**ADDENDUM NO. 1 TO PLANS AND SPECIFICATIONS**

**Project:** Orange Grove Vol. Fire Station # 2 Bldg. Addition (6801 Rocky Ridge Road)  
**Date:** Friday, March 6, 2026  
**By:** Jorge Rodriguez, AIA   
**Bid Date:** March 12, 2026  
**Bid Time:** 2:00 P.M. EST  
**Bid Location:** Orange Grove Fire Station # 1 (6800 Orange Grove Road, Hillsborough, NC 27278)

DATE: APRIL 21, 2025  
 DRAWN BY: MEG  
 CHECKED BY: MEG  
 SHEET NO. P-1

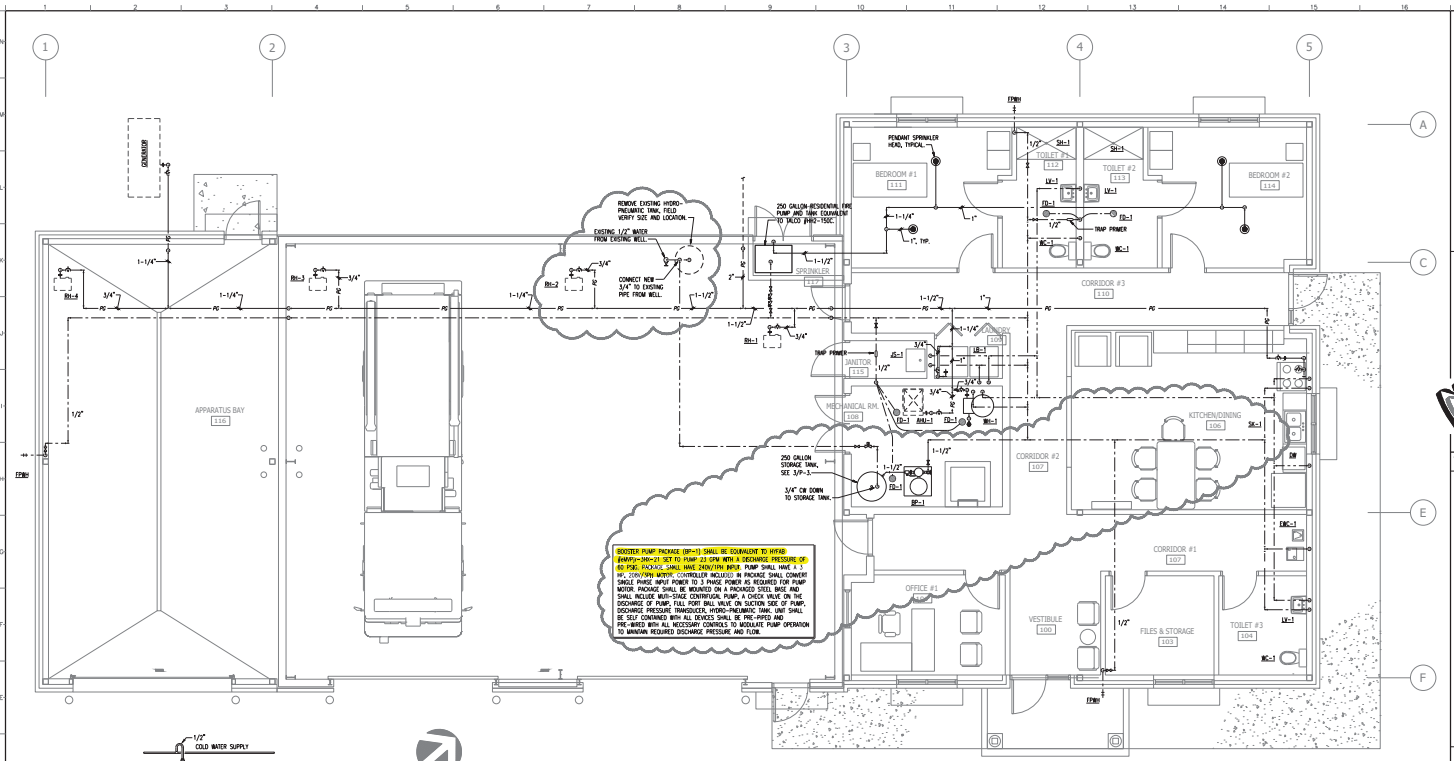
- 1. Sheet P-1:**
  - a. Remove existing hydro pneumatic tank on well system (located in apparatus bay). Connect new water line to existing water line where it enters the building.
  - b. Replace booster pump and new large hydro-pneumatic tank with packaged booster system which includes booster pump and hydro-pneumatic tank, BP-1 (in Mechanical Room).
  - c. Replace pressure rated steel storage tank with plastic, vented, non-rated storage tank. Provide storage tank with level controller and solenoid valve. Interlock level controller with well pump control. 1 (in Mechanical Room).
